Re: Response to Comments for LOMR for Brickhouse Gully;
City of Houston
Brickhouse Gully (E115-00-00)

Below are our responses to the third HCFCF courtesy review comments to the LOMR for Brickhouse Gully dated April 4, 2014.

CITY OF HOUSTON
 Department of Public Works and Engineering
 Geographic Information & Management System (GIMS)
THIS MAP IS PROVIDED AS THE BEST INFORMATION AVAILABLE. THE CITY DOES NOT WARRANT THE ACCURACY OF THIS INFORMATION.

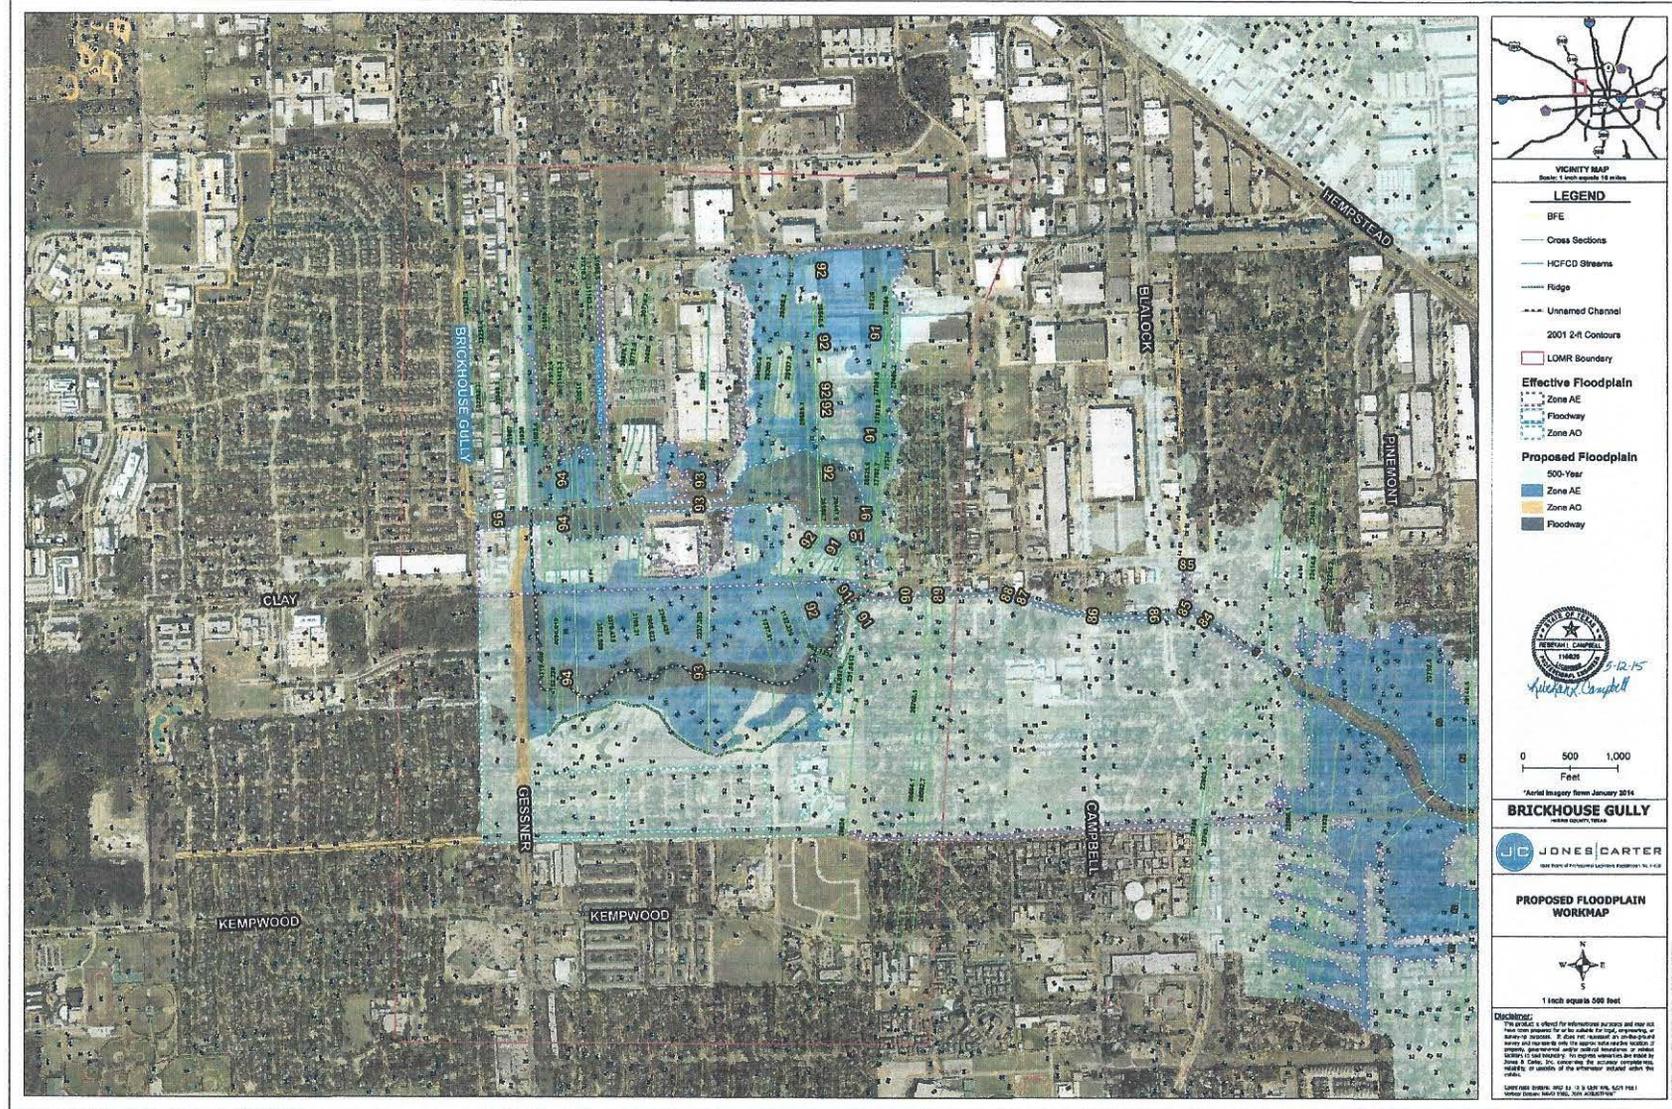
3. **Comment:** Please provide documentation that there is a defined flow path through the new channel in the golf course.

Overflow enters
golf course on
western boundary
of golf course at
Gessner Drive

Overflow Leaves
at Gessner
Drive

Well-defined flow
path through
golf course.

Flow re-enters
Briarhouse Gully
through concrete
overflow structure

Response: Attached is an exhibit from the City of Houston Geographic Information Systems (GIMS) website showing sheetflow patterns in the LOMR revision area. The exhibit shows there are well-defined sheetflow paths down Gessner and through the golf course lake system. As discussed in the response to comment 2 above, flow enters the golf course channel on the western boundary of the golf course with Gessner Drive.

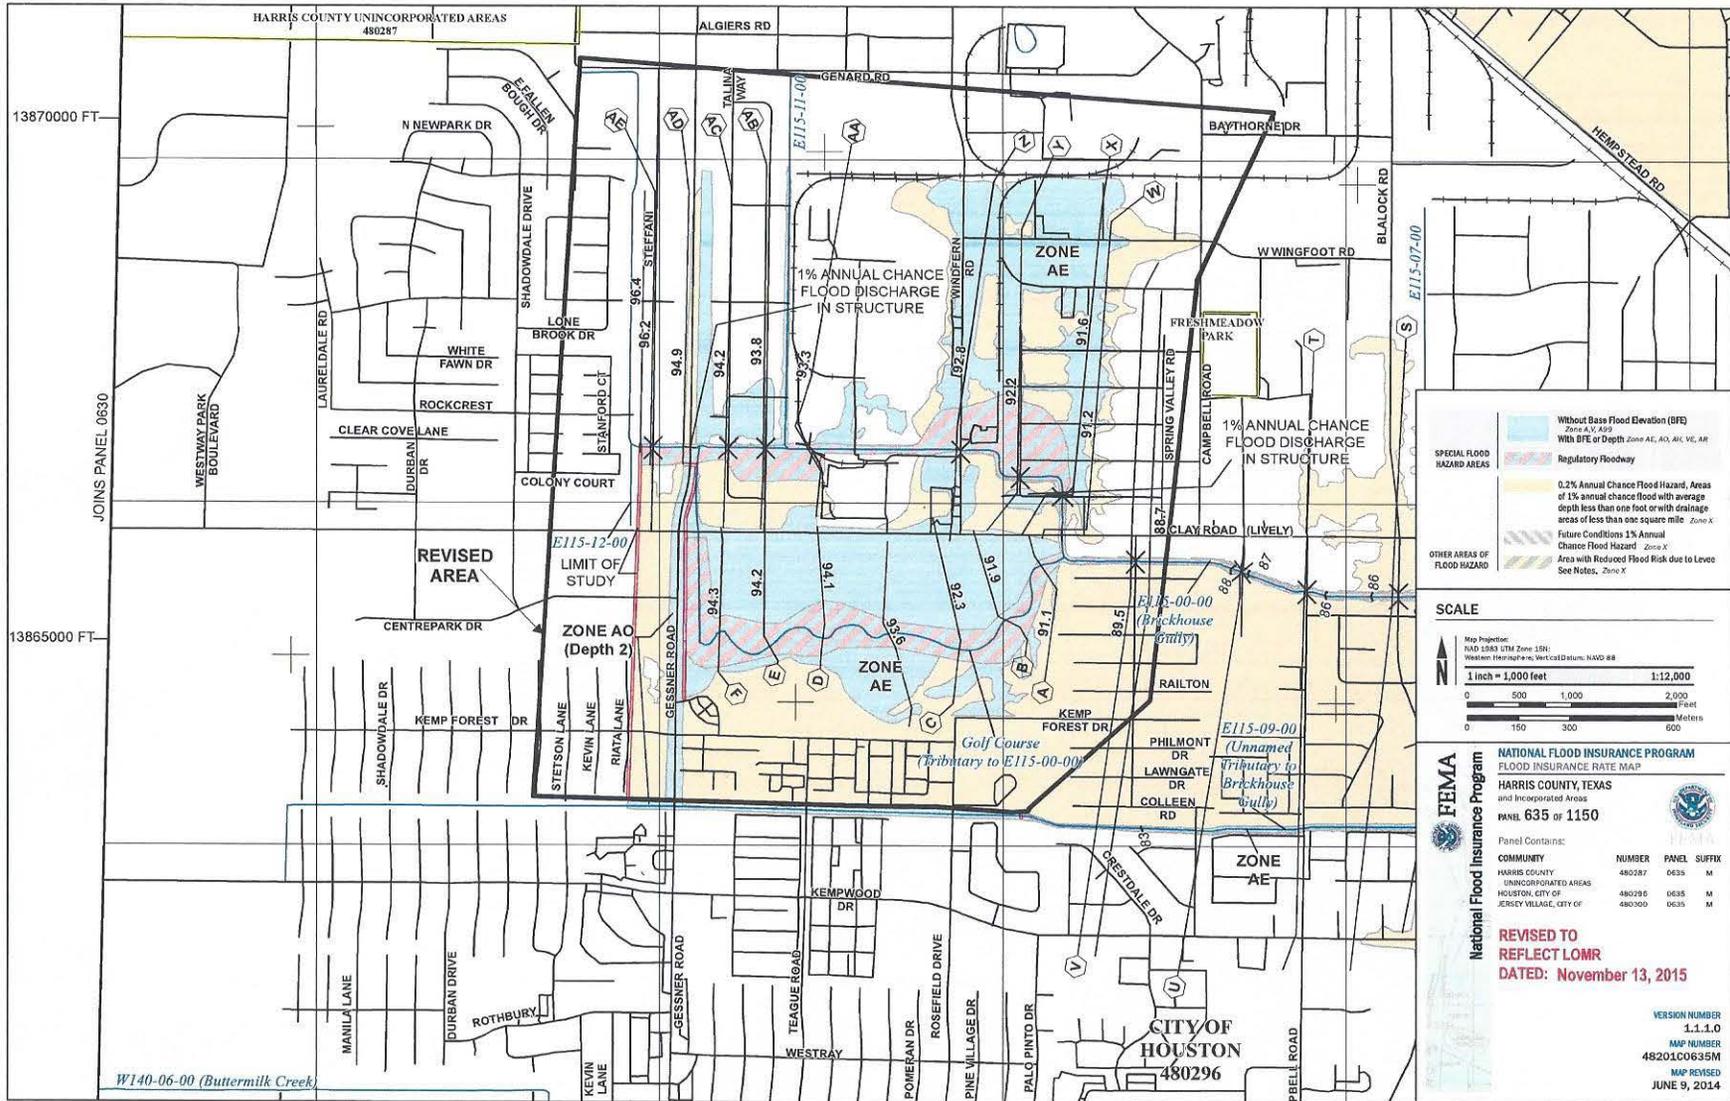
All annotation on image is as received from HCFCD. This is the only image found with overflow entering from Gessner as narrative states. Image was supplied as support to 2nd review response.

Signed topographic work map showing impossible flow path.

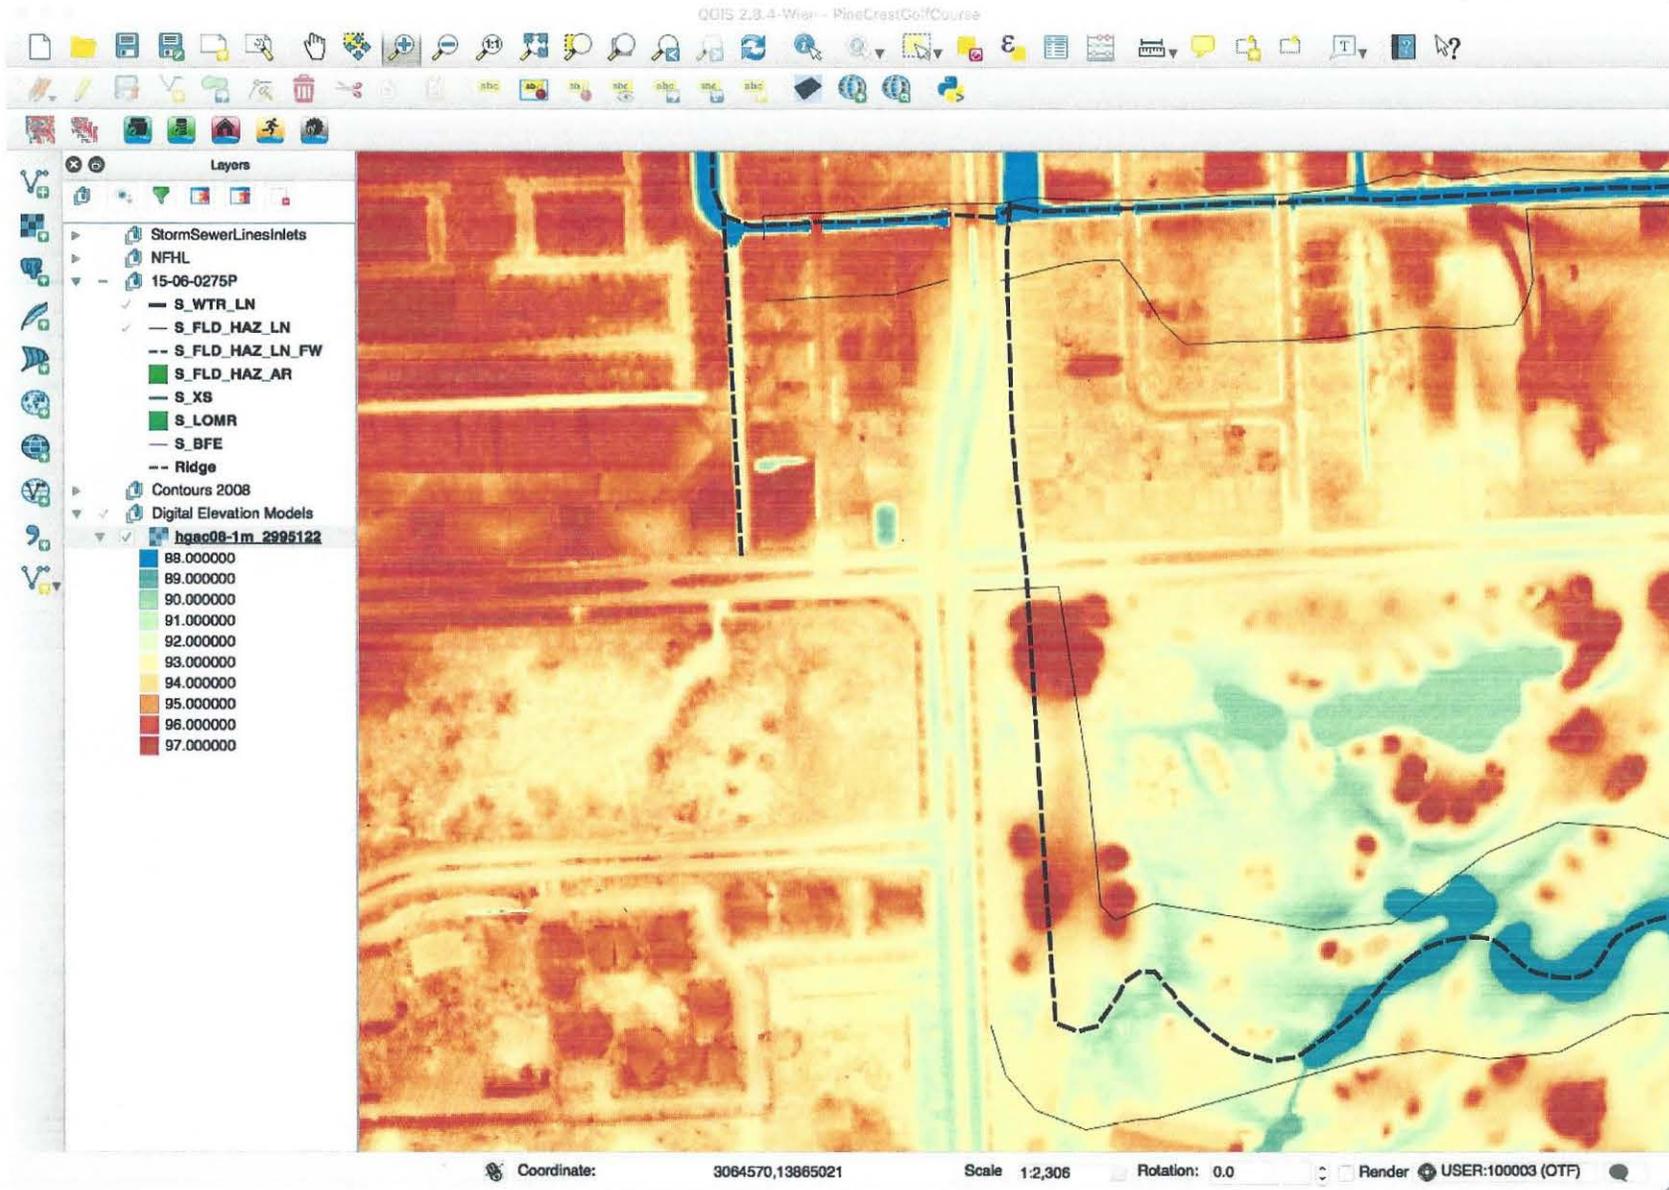
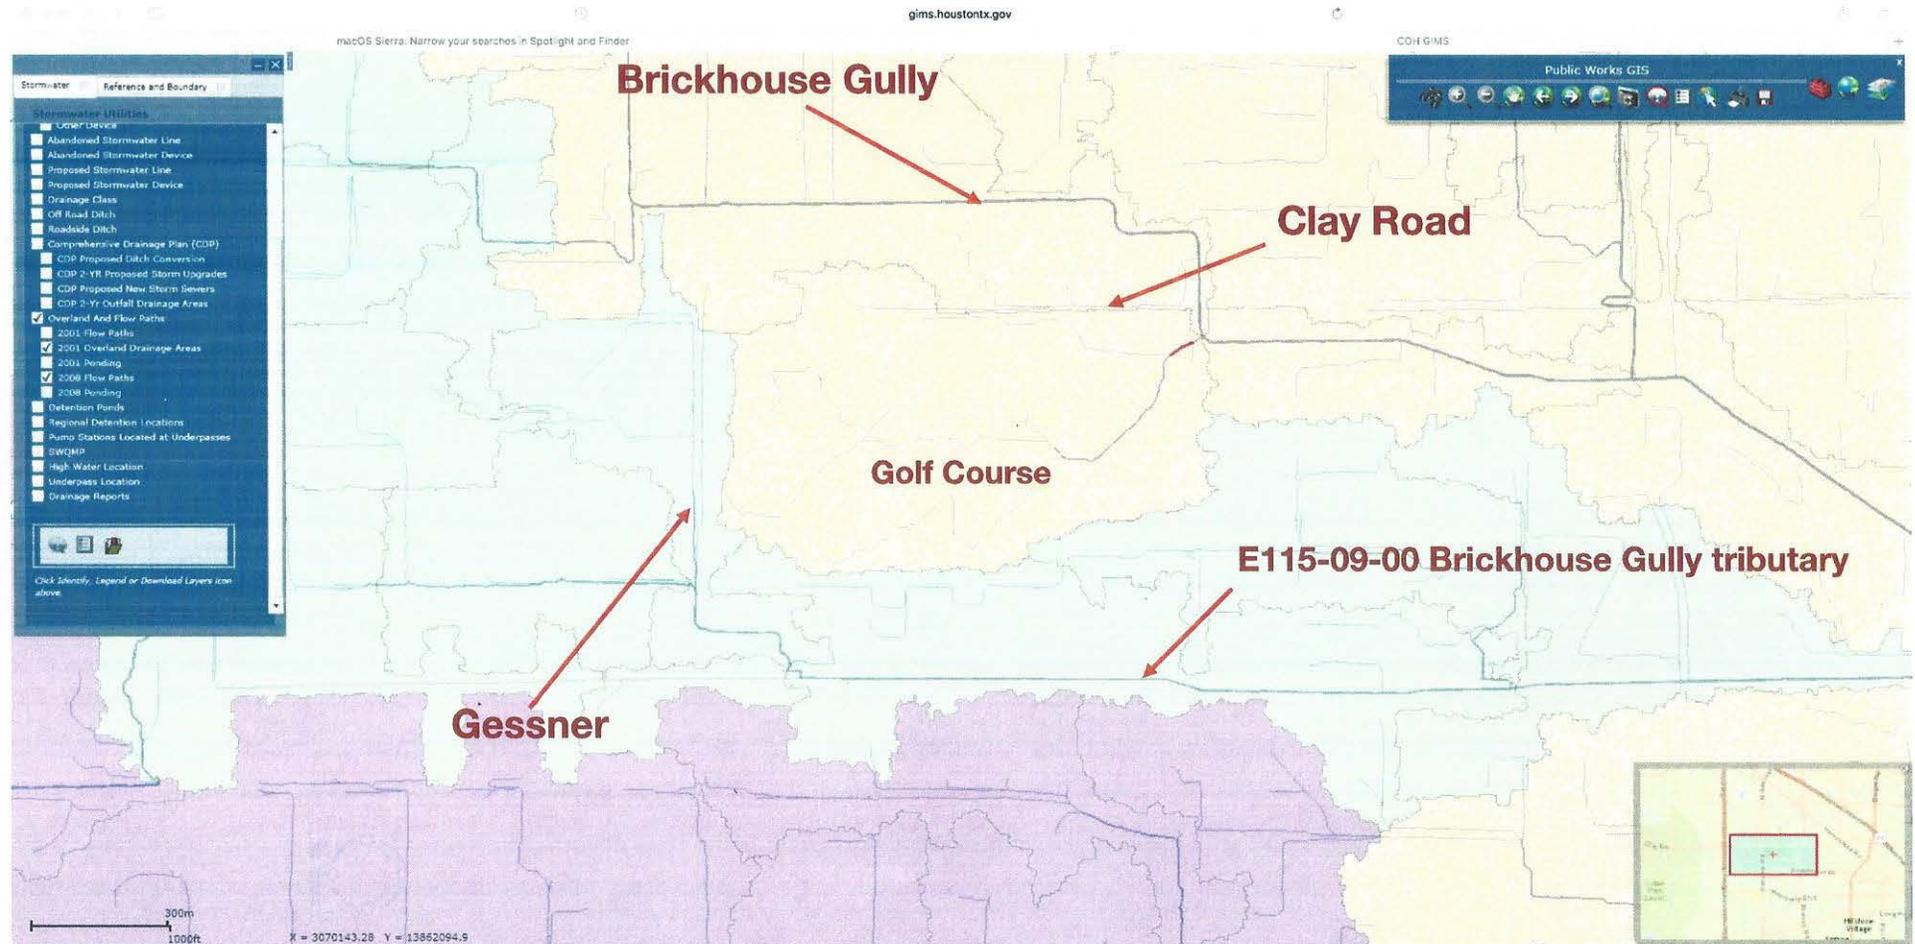
Impossible flow path shown on the LOMR

The impossible flow path shown on topographic work maps and the LOMR.

The LOMR arguments seem to conflict with City of Houston GIMS layers of Overland Drainage Areas and Sheet Flow. How does water enter the property from the west off Gessner? All of the Gessner sheet flow is shown going to the E115-09-00 tributary.
